CITY OF DARIEN
PLANNING AND ZONING COMMISSION
AGENDA

AGENDA MEMO
PLANNING AND ZONING COMMISSION
MEETING DATE: February 3, 2016

PZC 2015-20: 8433 Bailey Road, Society of Mount Carmel – Society of the Little Flower – National Shrine to St. Therese: Petitioner requests approval of a final plat of subdivision and a major amendment to an approved PUD, including but not limited to: a new shrine chapel, reconstruction of parking lots and an additional parking lot, a new drive-way onto N. Frontage Road and new pedestrian connections and plaza.

Subject: National Shrine of Saint Therese – Improvement Plans
(CBBEL Project No. 950323H177)

**ST. THERESE CHAPEL
PLAT OF SUBDIVISION**

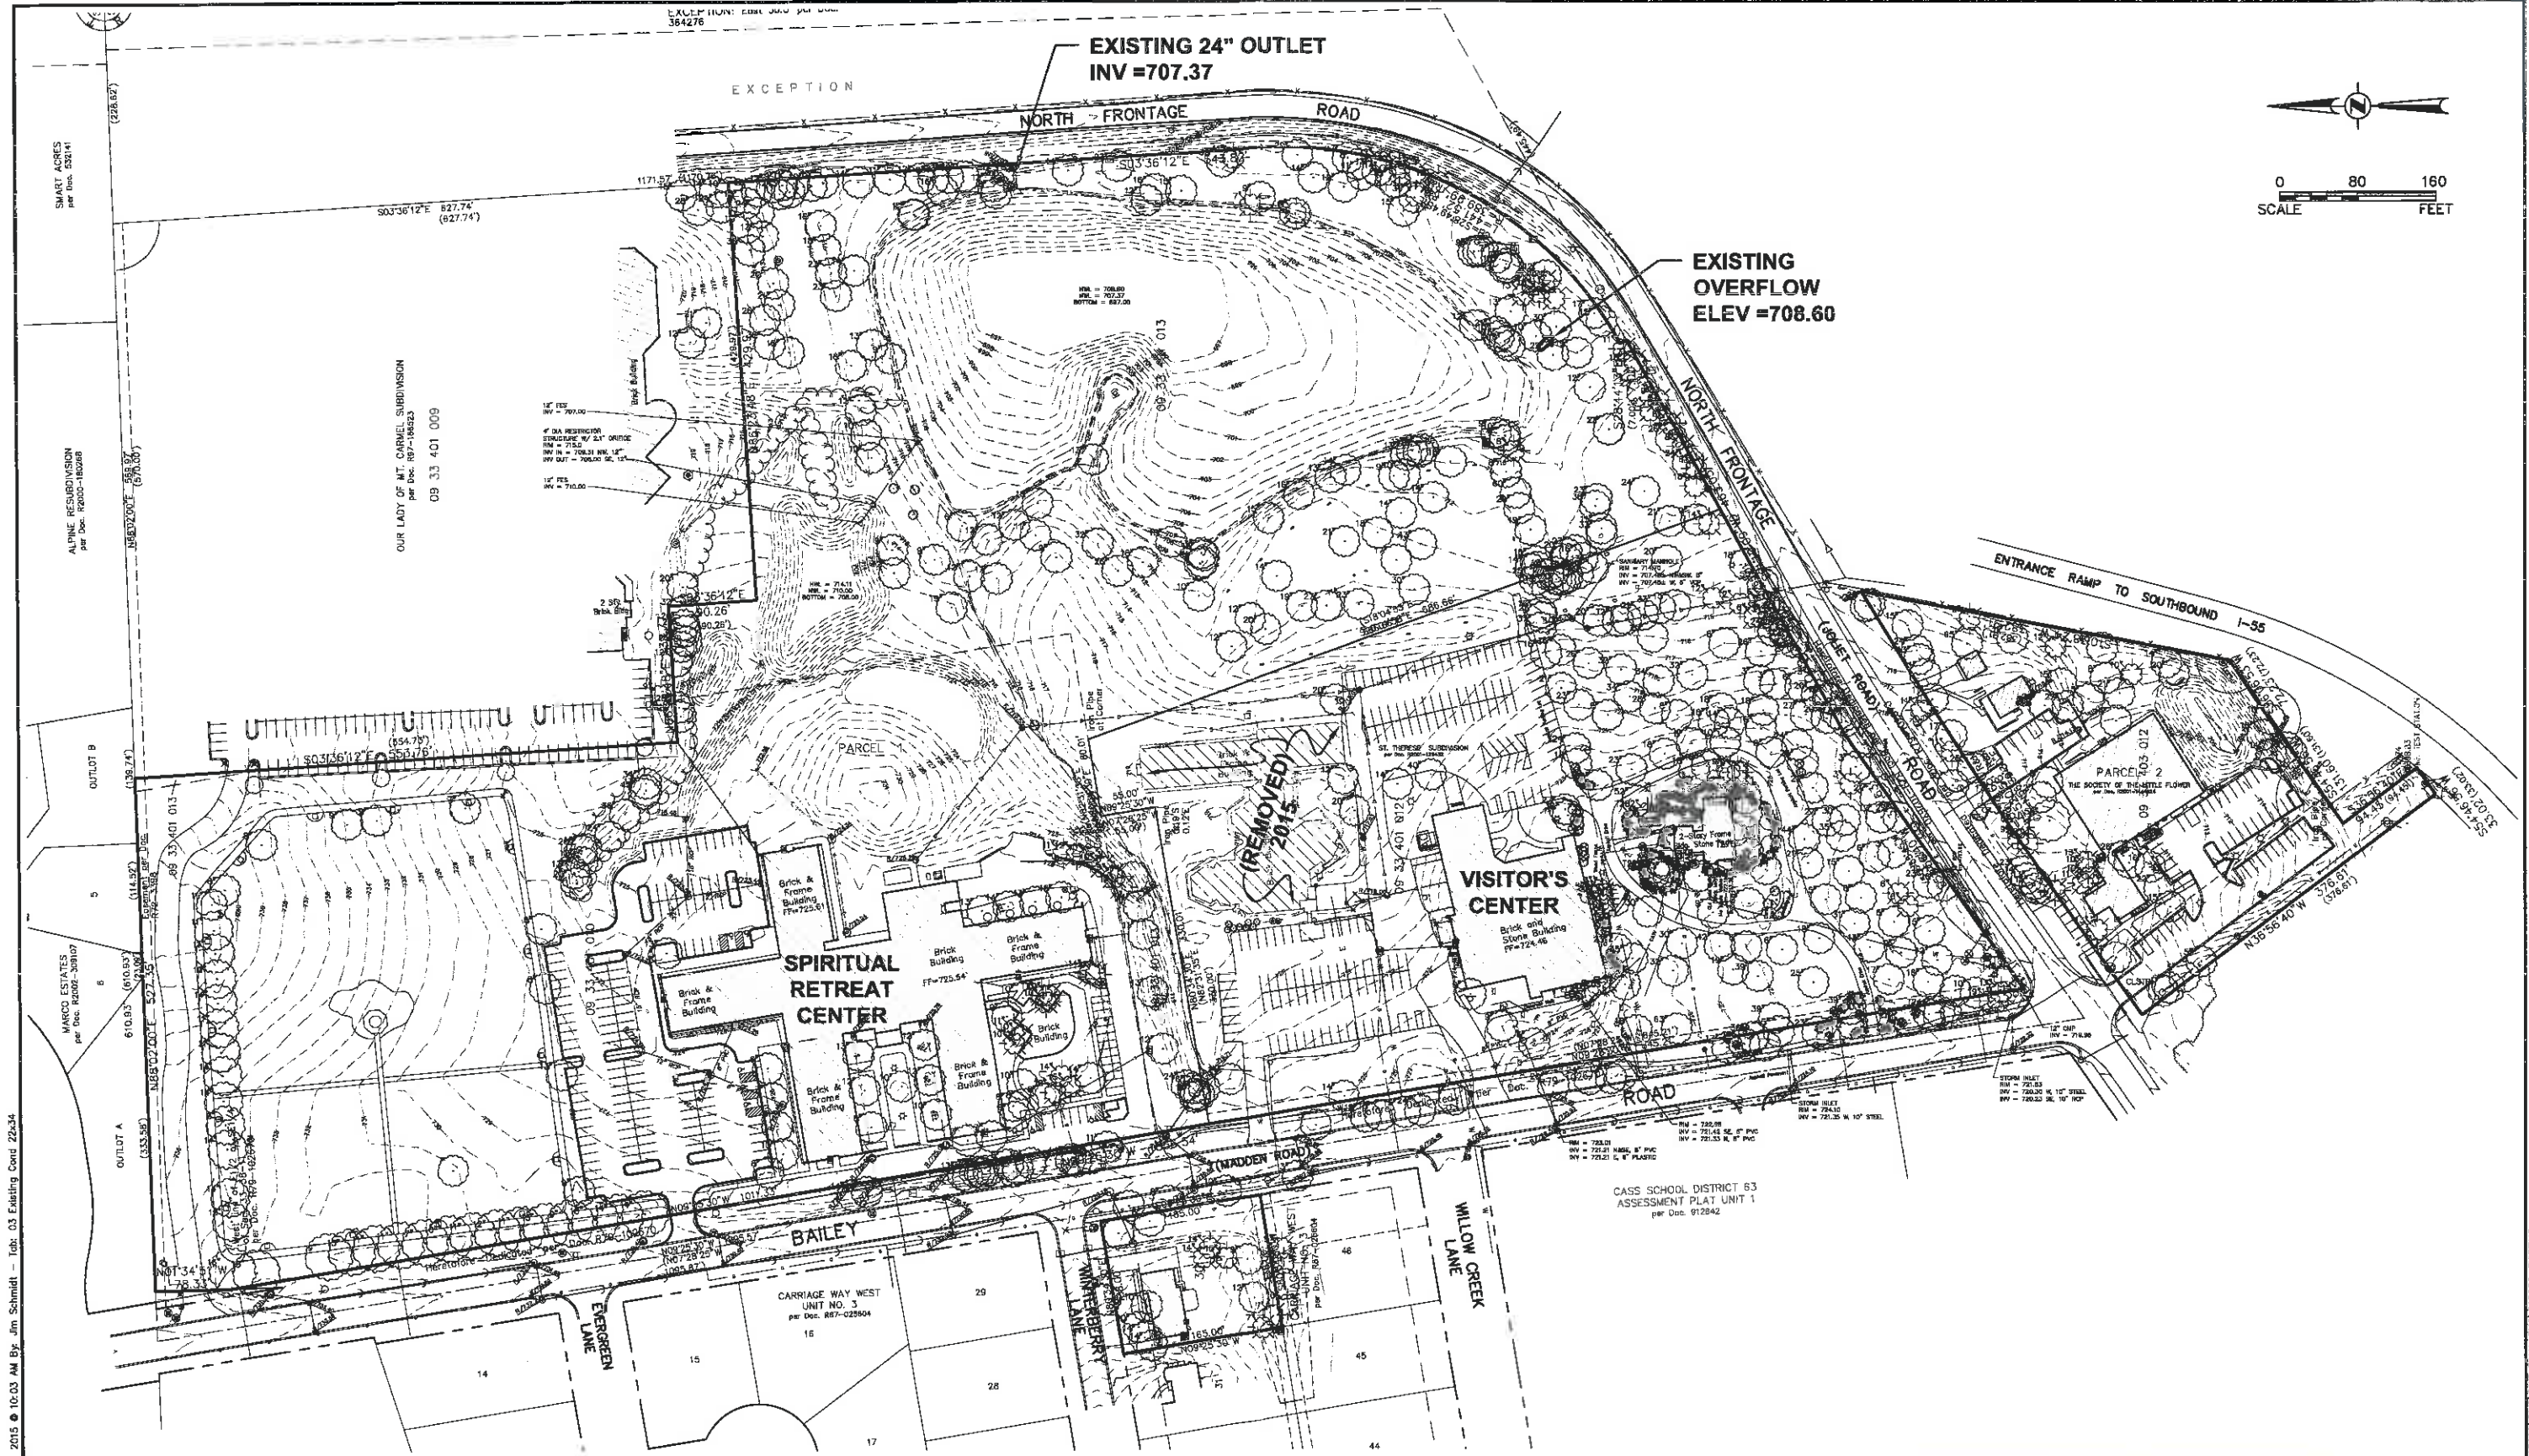
1. Provide a Stormwater Drainage and Detention Easement over the detention basin.

OVERALL SITE PLAN

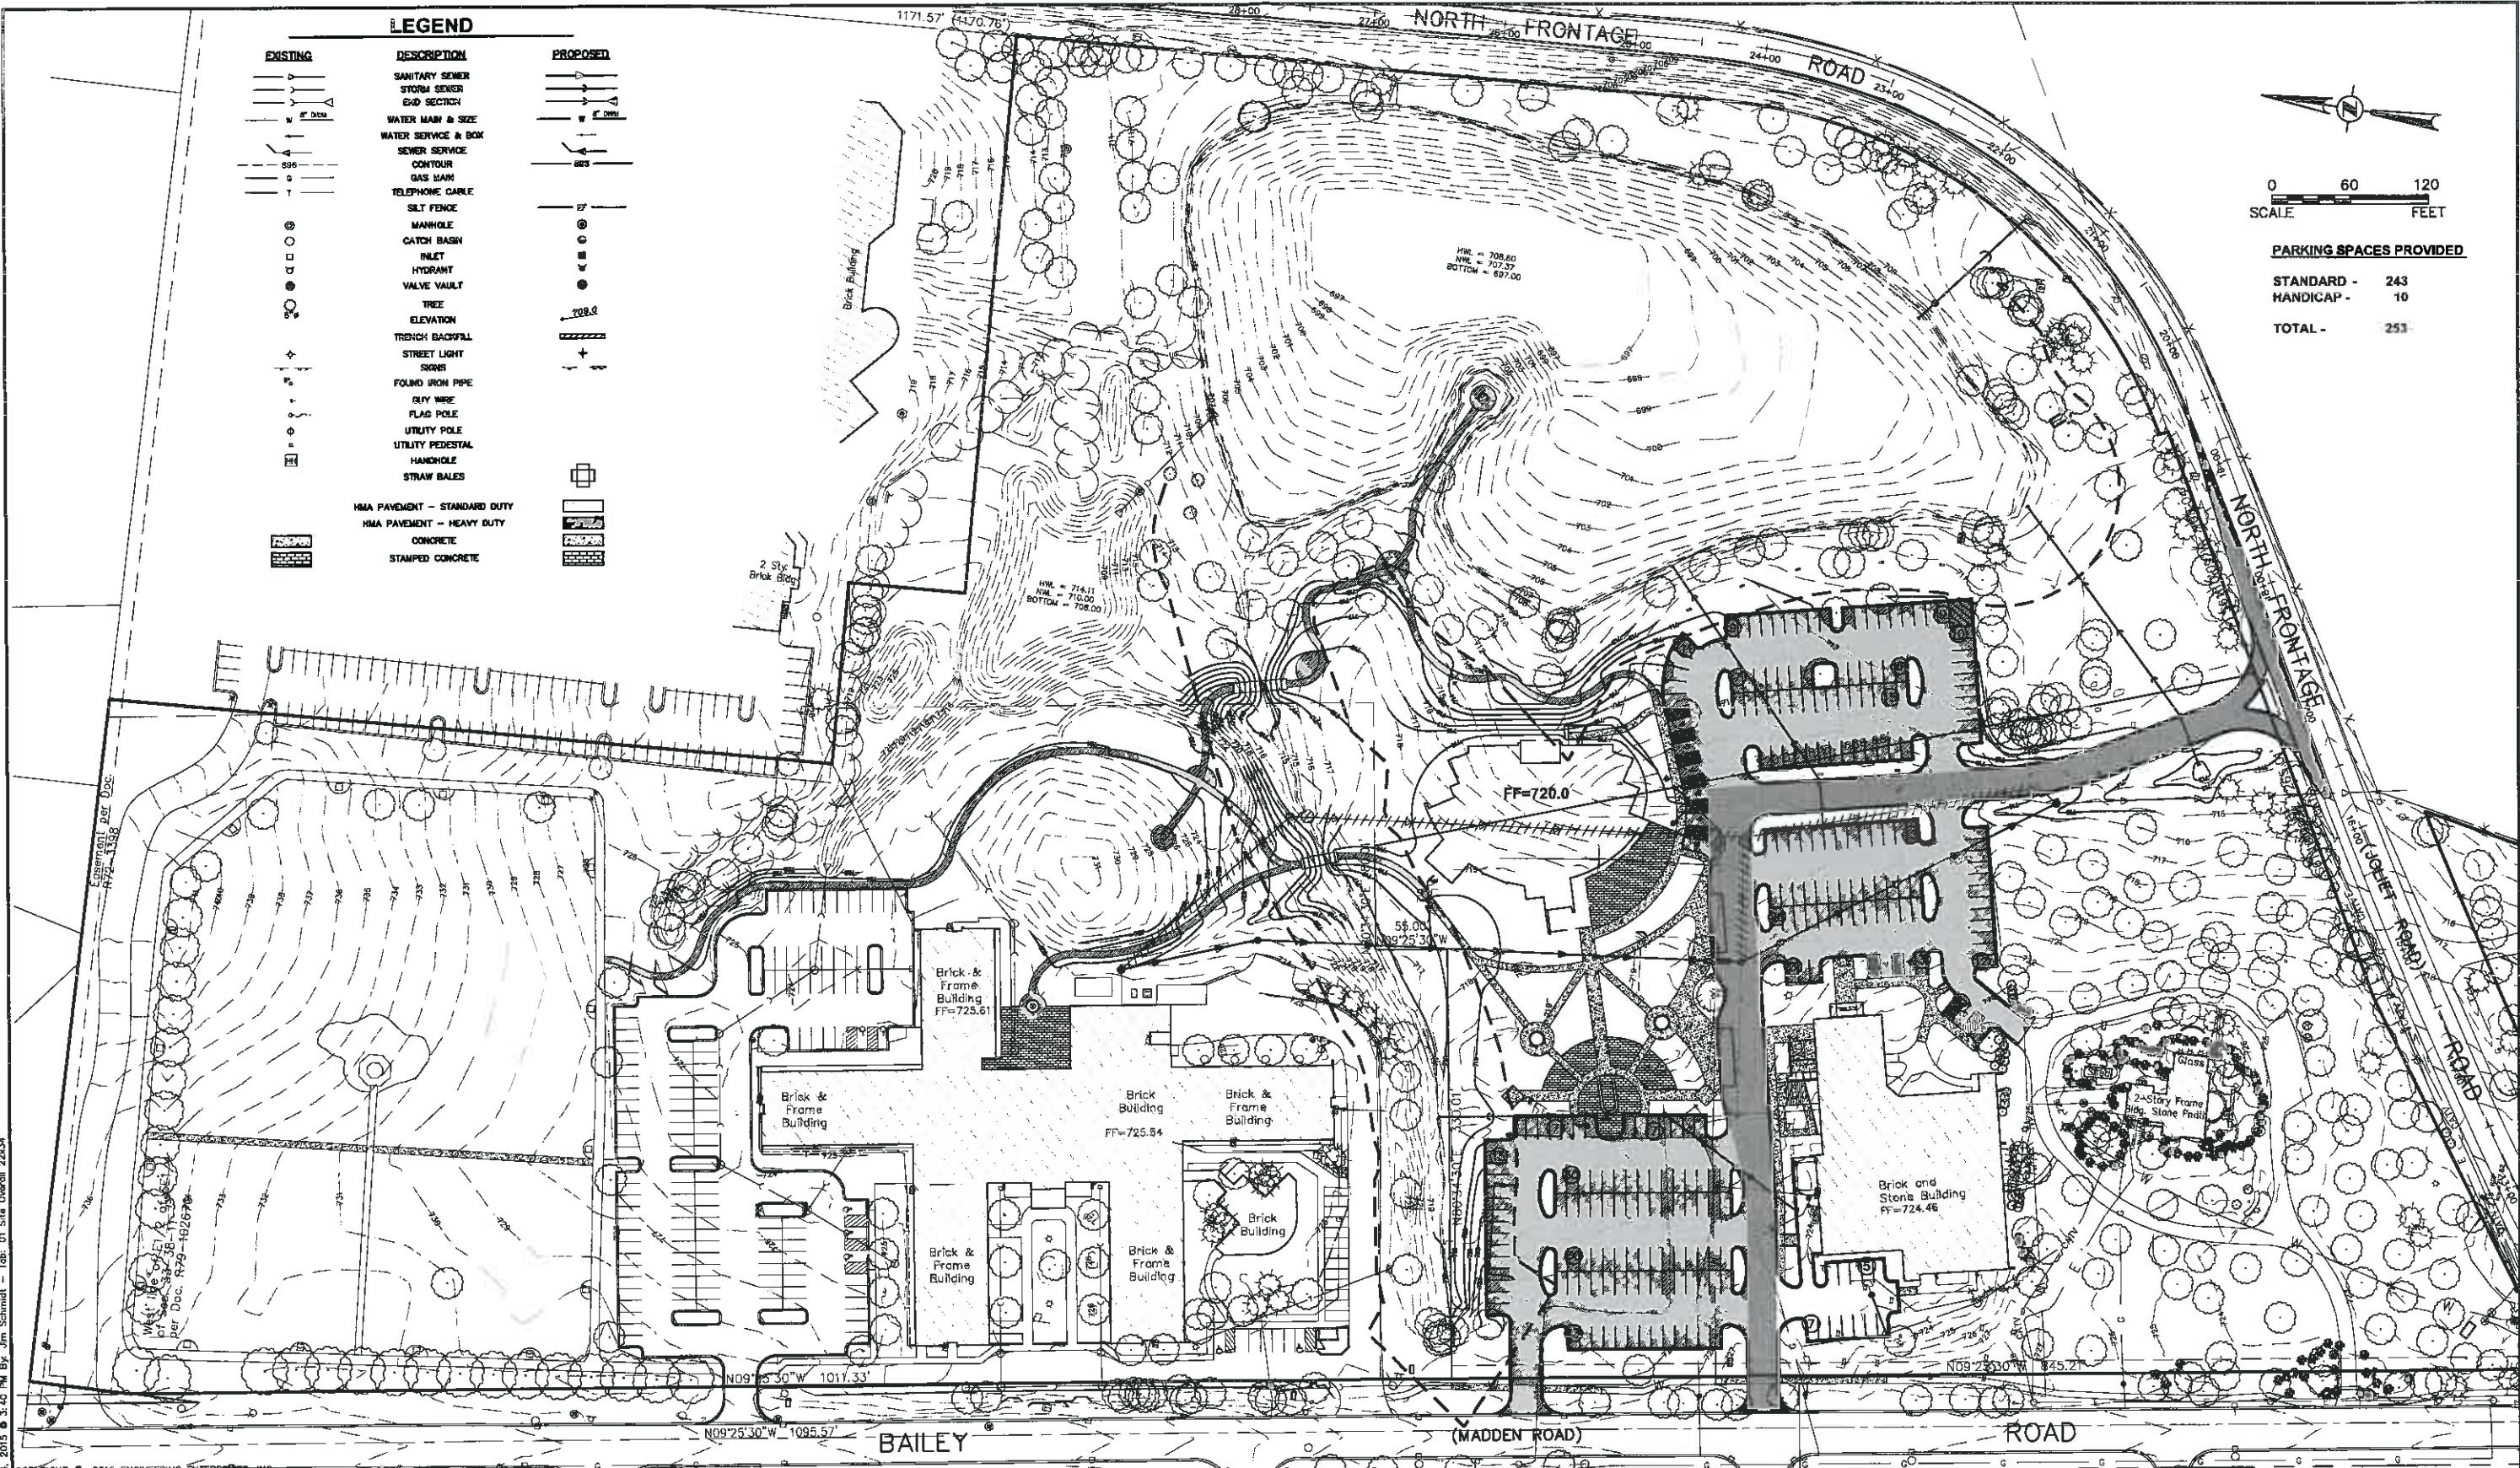
The site plan needs to include dimensions for parking stalls, drive aisle widths, driveway widths, distance between driveways along Bailey Road, building foundations, for example.

The plan provides 253 parking stalls, which includes 10 handicapped accessible stalls. Additional parking, not included in this figure, is located to the north of the spiritual center. It appears adequate parking is being provided, however, the petitioner should describe how the

various campus activities fluctuate throughout a typical day, i.e. peak parking demand times.

1. Include this sheet on the Improvement Site Plan set.

1. Provide a plan set for the proposed pedestrian bridges.
2. Add the overall site plan (sheet 1 of 1) to the site improvement plans with additional dimensions such as parking stall size, aisle width, curb radii, etc.
3. A permit from IDOT will be required to work in the North Frontage Road right-of-way.
4. The sanitary sewer shall be reviewed and approved by the DuPage County Public Works.
5. Verify if IEPA permits are required for the watermain.
6. An IEPA NPDES permit is required and the SWPPP must be submitted to the City.
7. Verify with the fire protection district that the proposed parking lot will accommodate their fire protection equipment. Also verify the locations of the fire hydrants.
8. Add a note to contact the City of Darien Water Department prior at least 48 hours in advance prior to watermain work and hydrant installation.

TITLE: EXTERIOR ELEVATIONS - CHAPEL	
DATE: 12/15/2015	PROJECT #: 2015-083
PRINCIPAL: BFG	SHEET: A3.2
DRAWN BY: JAS

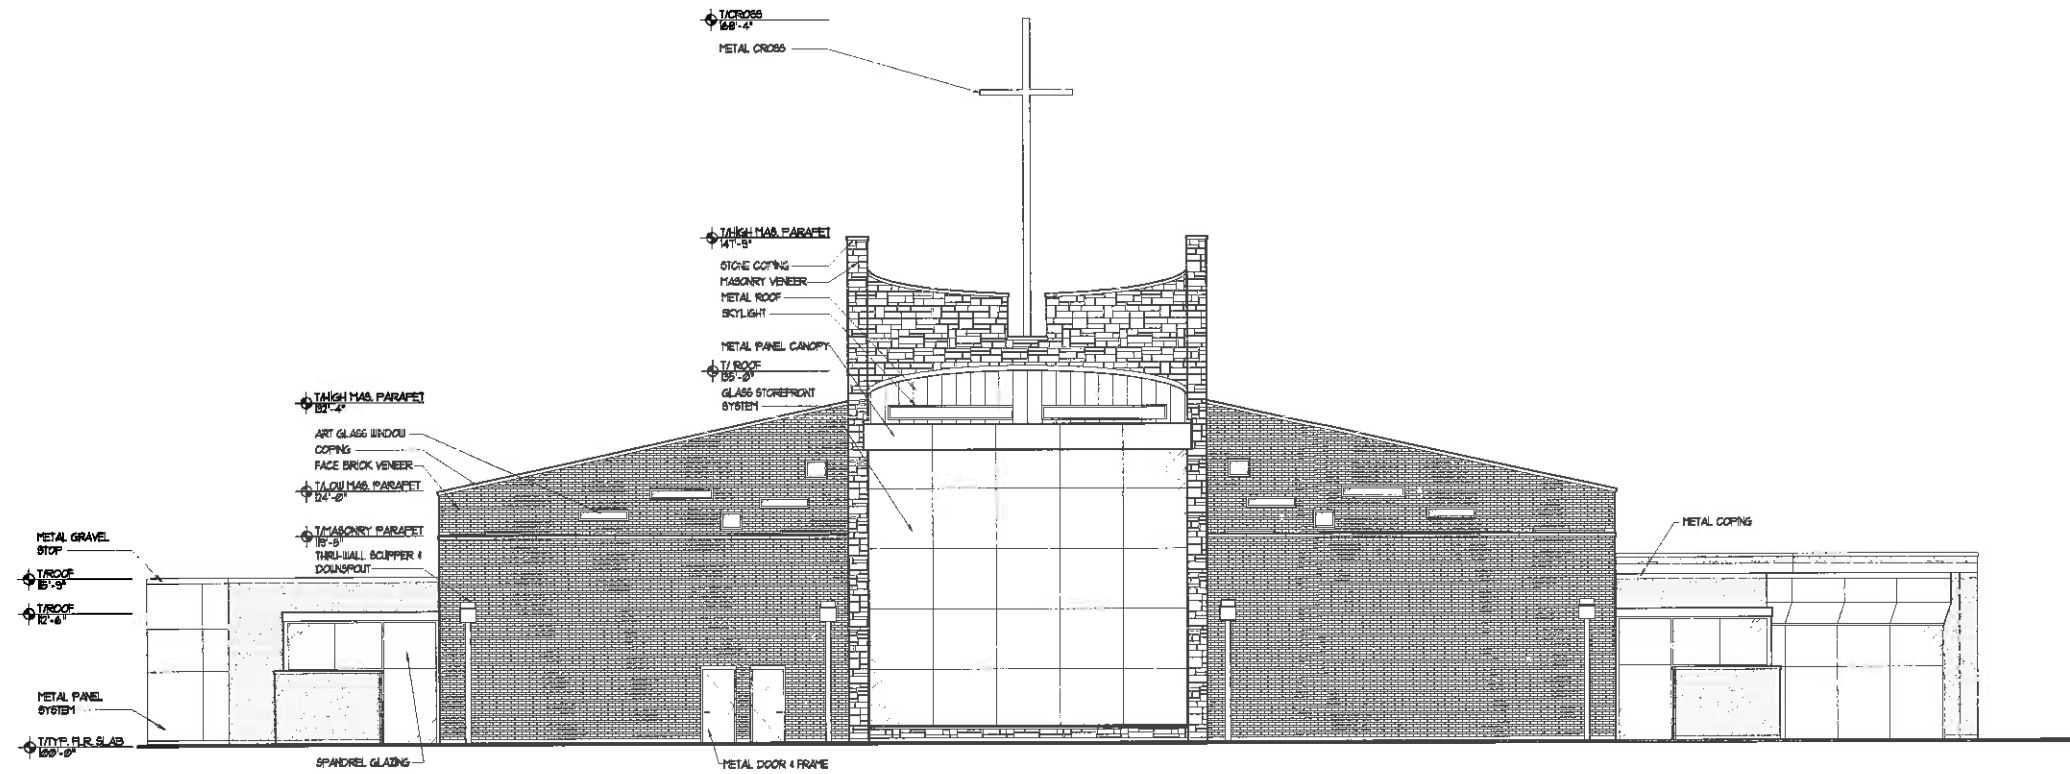
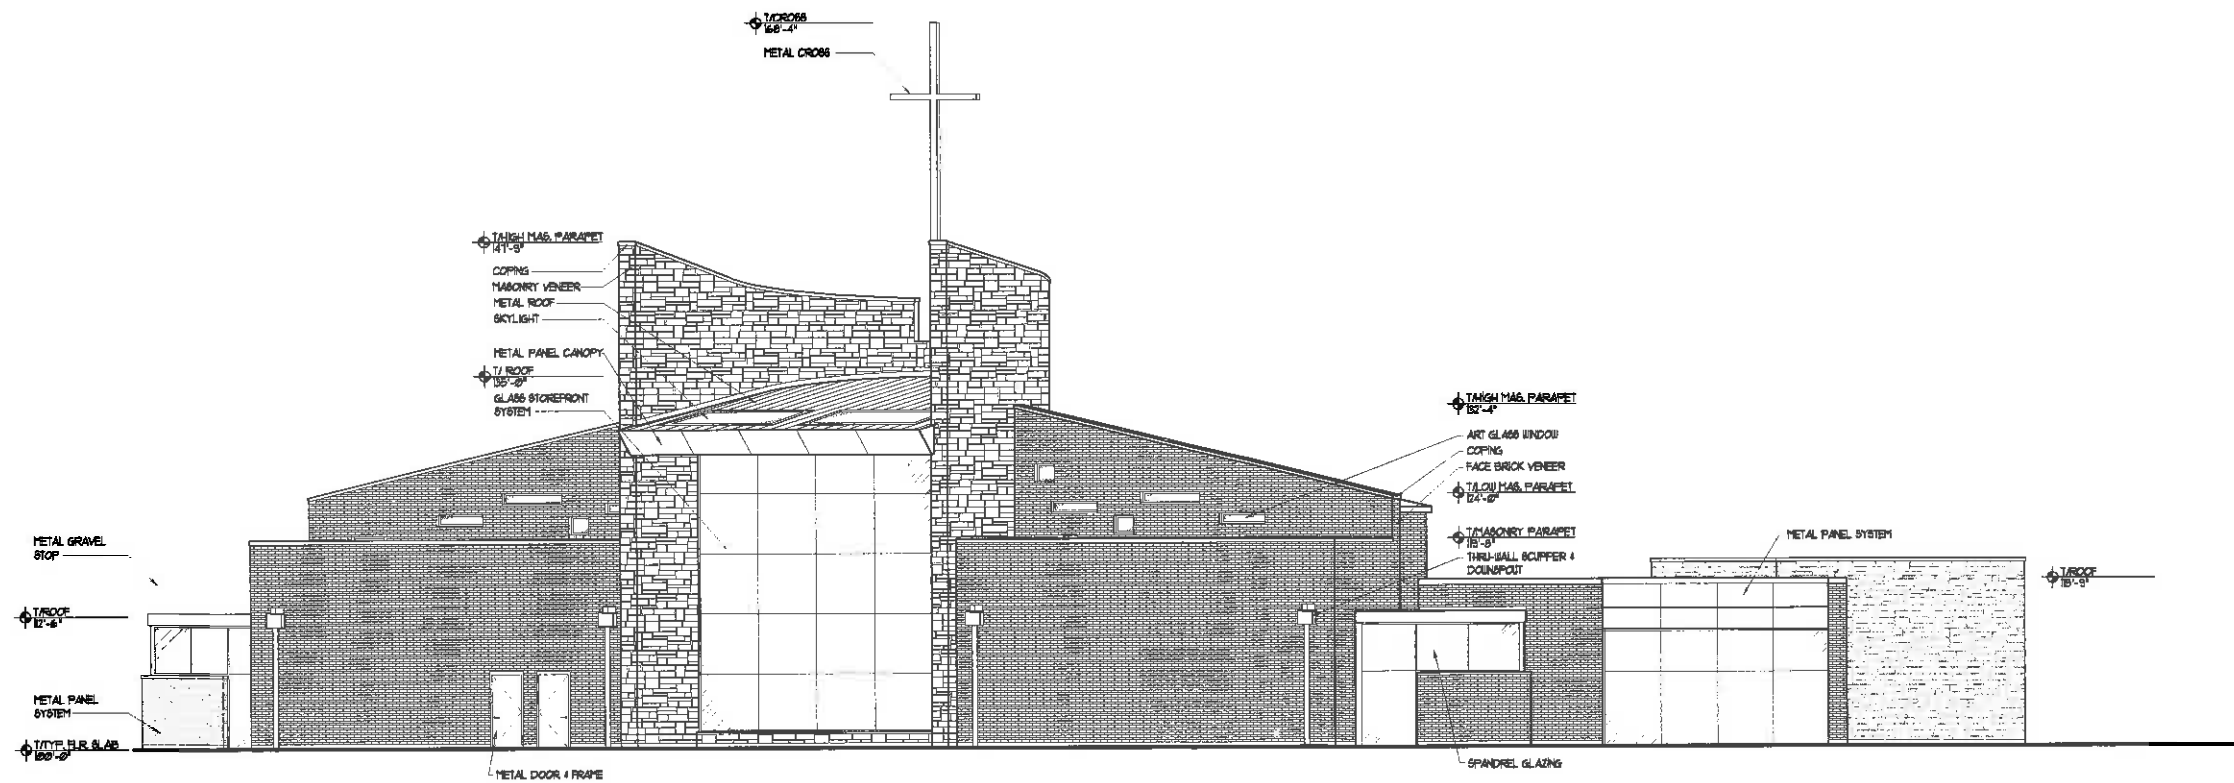
Within the R-3 zoning district, the maximum building height is 3 stores not to exceed 35 feet. The building height is measured to the highest elevation of the roof in the case of a slant or flat roof, at the center of the building front. The top the roof is 31 feet, top of parapet is 47'-9", with a meal cross on the roof extending to 68'-4".

The plan includes a plaza with a tower. The tower will have a masonry veneer with a metal cross on top. The tower height is 48'-6", with the top of the cross at 68'-1".
